ROOF OPENING PANEL DOES NOT CLOSE ON ONE-TOUCH OPERATION AND 'BOUNCES BACK'

Model: S-TYPE

S501-21: This Technical Bulletin has been issued to address customer concerns that the roof opening panel does not close on one-touch operation and 'bounces back'.

Fig. 1

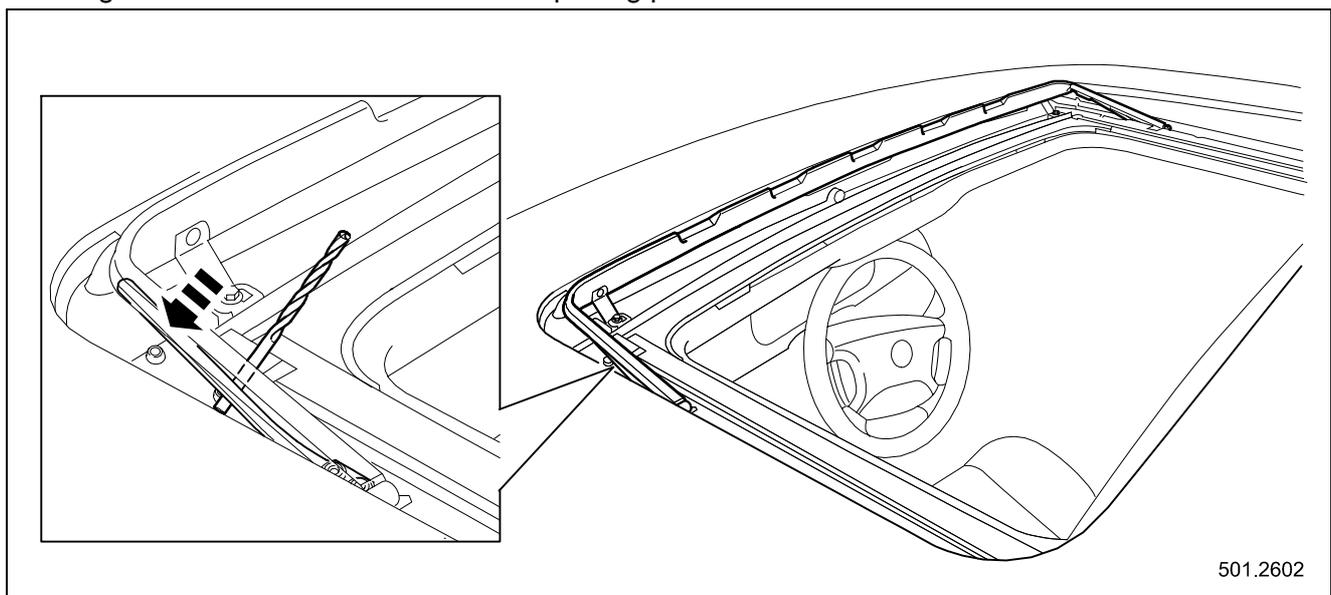
There is a possibility that the roof opening panel may not close on, one-touch operation, and may 'bounce back', due to excessive wind deflector spring strength. The roof opening panel motor will have to have a de-synchronization and synchronization procedure carried out, and carry out a re-profile of the wind deflector spring. Should a customer express a concern, follow the workshop procedure outlined below.

- 5 Position shank of a 4.0mm twist drill under base of the spring by the rivet head, and push the deflector down over the drill until it bottoms out to re-profile the spring (see Fig. 1).
- 6 Carry out step 5 for the right hand side of the roof opening panel.
- 7 Close driver's door.
